Service Bulletin

No. : MZ05-022

Model: SA8260, SA-17S1

Subject: Cannot playback specific Super Audio CD Disc.

PV16-SERVO PWB

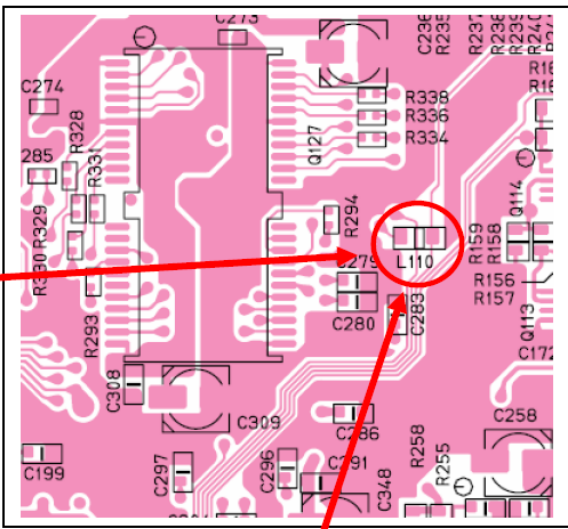
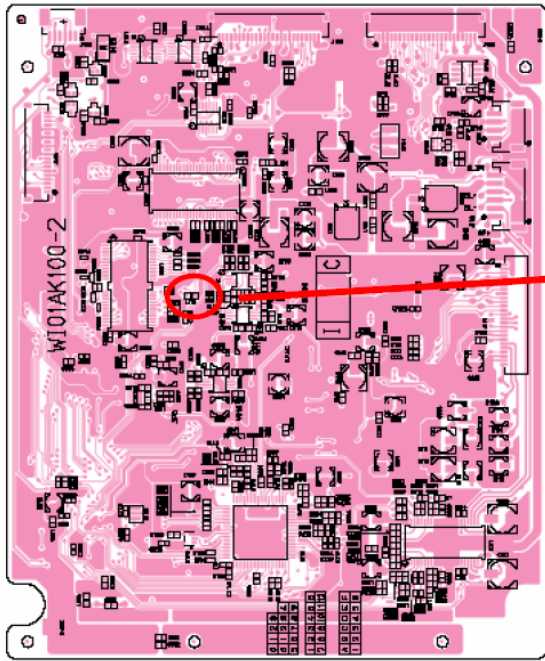
Symptom: Can not read the invisible watermark of specific Super Audio CD:
R.Strauss /Alps symphony (UCGG-7011).

L110

Solution: L110 Ferrite Core has been changed to a Chip Resistor (100 OHM)
on the PV16-SERVO PWB.
